Department
for Transport

Interim changes to the Guidance on the use of Tactile Paving Surfaces

August 2015

Figure 1.1: Treatment of an uncontrolled crossing point at an irregular corner under the existing tactile guidance (left) and under the proposed amendment 1.1 (right).

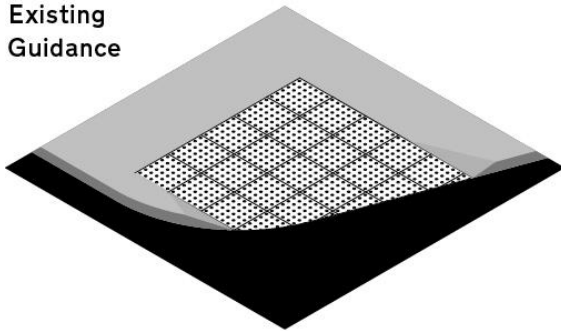
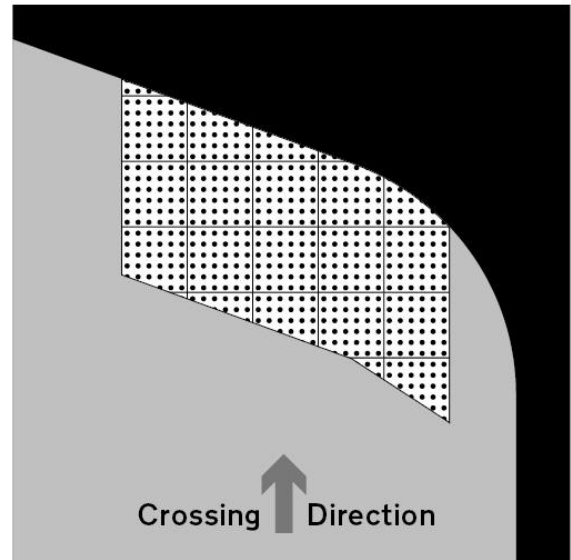
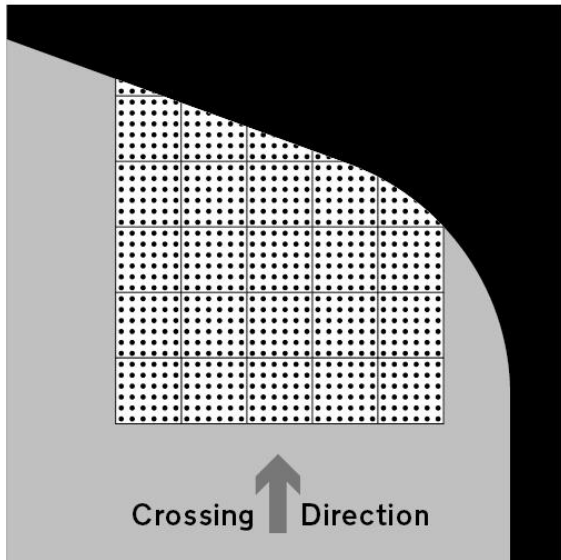
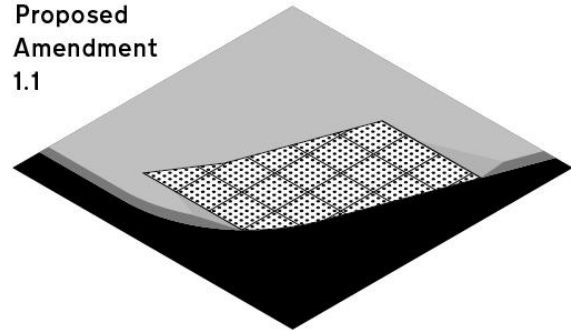
5.1 Replaces:

“The back edge (of the section of tactile surface which extends across the dropped kerb) should be at right angles to the direction of crossing (Figure 3 page 29). This may not necessarily be parallel to the kerb.” 1.5.1.2 (p28)

It was acknowledged by workshop participants that the expansive trapezoidal areas of blister surface, created by the strict application of the perpendicular back edge rule at many irregular crossing points, were not providing the accurate orientation information many people with sight impairments need to navigate. It was felt that the increase in accuracy and specificity that would be provided by a smaller, simpler area of blister surface would justify the loss of the information provided by the perpendicular back edge.

5.2 With:

The back edge (of a section of tactile surface marking the boundary between the footway and carriageway) should be parallel with the boundary and set back in the direction of crossing by a fixed distance (typically 800 mm or 1200 mm).

This change should not affect the practice of laying the tactile surface so the blisters are aligned parallel to the direction of crossing nor the requirement for the provision of a stem at controlled crossing points 1.5.1.2 (p30).

Figure 1.2: Treatment of an uncontrolled crossing point at an irregular corner under the existing tactile guidance (left) and under proposed amendment 1.2 (right).

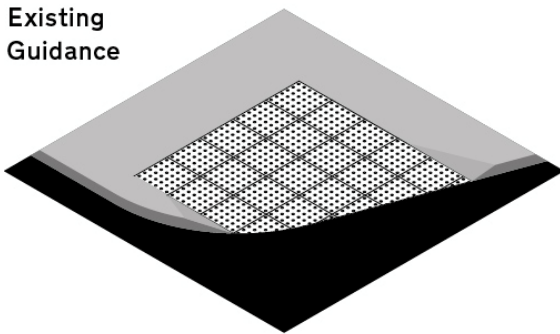
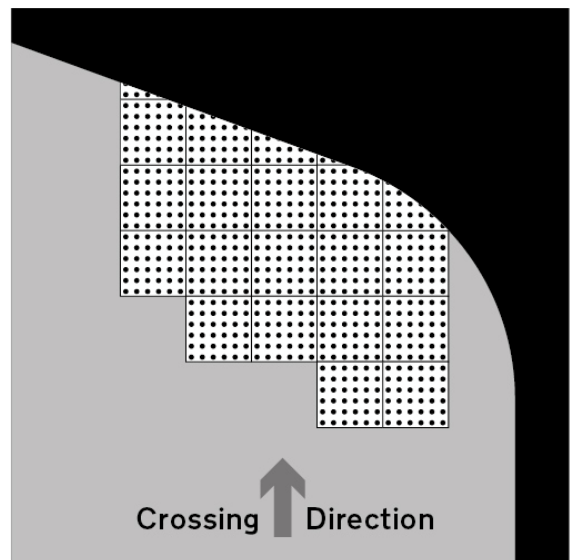
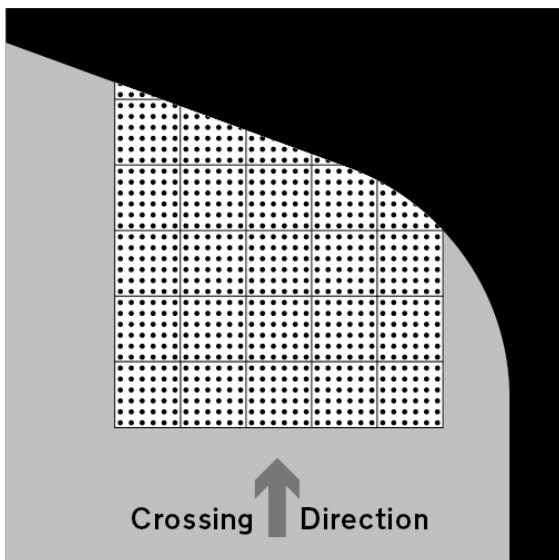
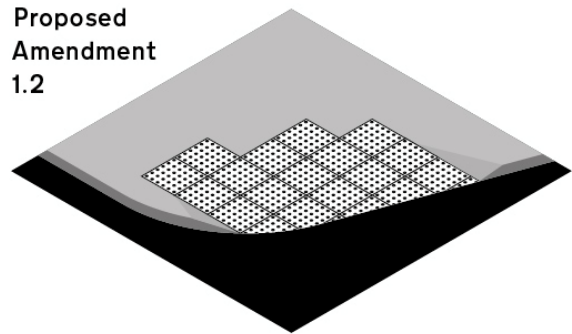
5.4 Replaces:

“The back edge (of the section of tactile surface which extends across the dropped kerb) should be at right angles to the direction of crossing (Figure 3 page 29). This may not necessarily be parallel to the kerb.” [1.5.1.2 (p28)]

It was acknowledged by workshop participants that the expansive trapezoidal areas of blister surface, created by the strict application of the perpendicular back edge rule at many irregular crossing points, were not providing the accurate orientation information many people with sight impairments need to navigate. A stepped approach would reduce the requirement for tactile tiles to be cut to match the kerb profile at the back of the installation (as they already are at the front).

5.5 With:

The back edge (of a section of tactile surface marking the boundary between the footway and carriageway) should approximate the line of the boundary using a stepped approach with the appropriate minimum distance (typically 800 mm or 1200 mm) maintained but in some places increasing so that the back edge of each individual tile remains perpendicular to the direction of crossing.

This change should not affect the practice of laying the tactile surface so the blisters are aligned parallel to the direction of crossing nor the requirement for the provision of a stem at controlled crossing points 1.5.1.2 (p30).

Figure 3.1: Proposed deployment of tactile surface(s) in level surface contexts

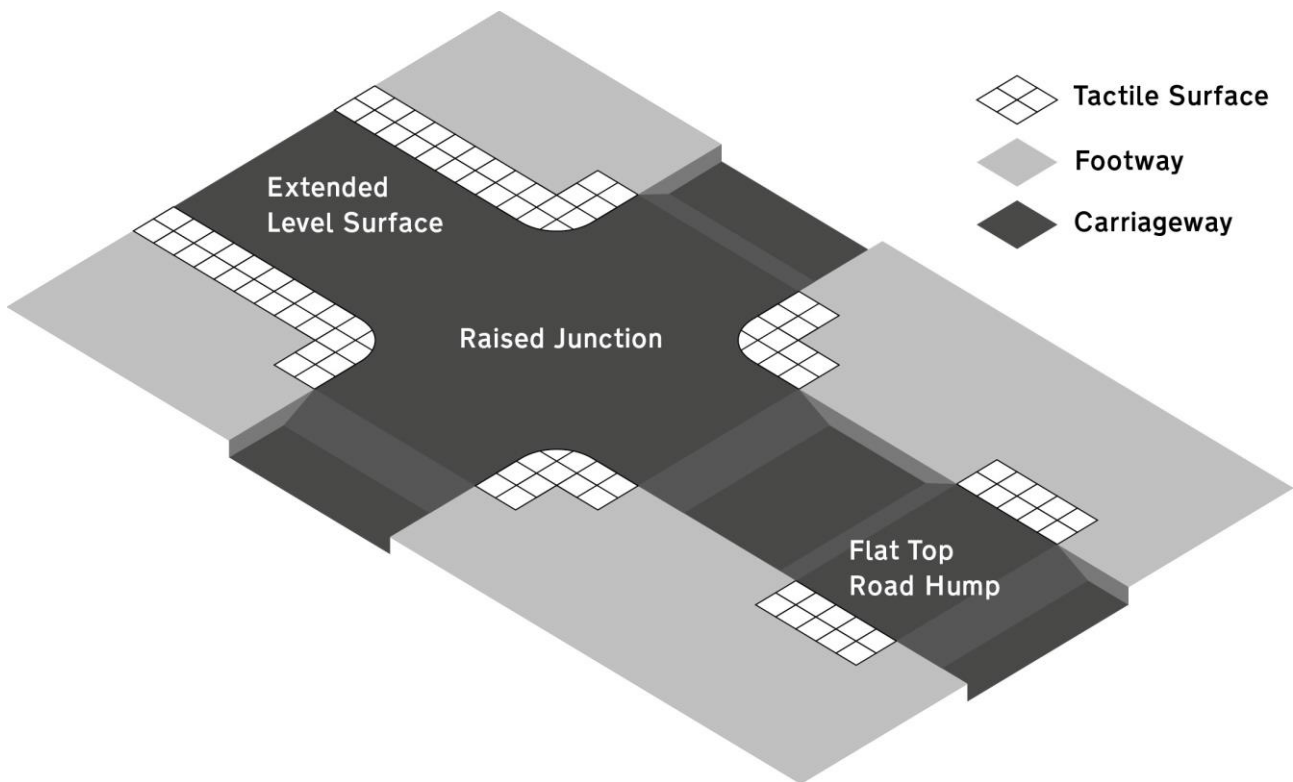
7.1 Replaces:

“Where an extensive area of the carriageway has been raised then it will not be appropriate to install the tactile surface along the full length. In those circumstances the tactile surface should be limited to the ‘crossing’ area (Figure 15 page 49), and the remaining raised carriageway either side of the tactile surface should maintain a level difference with the footway of at least 25mm high or have a continuous physical barrier, for example, planters, railings” 1.5.5.1 (p48) [...] “Where the carriageway has been raised to the level of the footway around an entire junction, it is essential that visually impaired pedestrians are kept away from the radius by the use of continuous physical barriers, for example, guard railings (Figure 17 page 50).” 1.5.5.3 (p48)

Workshop participants agreed that there needed to be a simple, unambiguous rule to prevent the appearance of un-delineated level surfaces (for example where designers implemented the raised junction treatment described but omitted the guard railings). Research has indicated that 60mm is the minimum level change that can be reliably detected by people with sight impairments in the absence of tactile paving whilst 800mm is the minimum depth of tactile paving that can be reliably detected.

7.2 With:

Wherever there is no level change between carriageway and footway, or a level change of less than 60mm, the boundary between footway and carriageway should be delineated with a tactile surface of at least 800mm in depth. This rule should apply to any continuous barrier-free surface occupied by pedestrians and vehicles be that a flat top road hump, a raised side road or junction, or an extended level surface area.
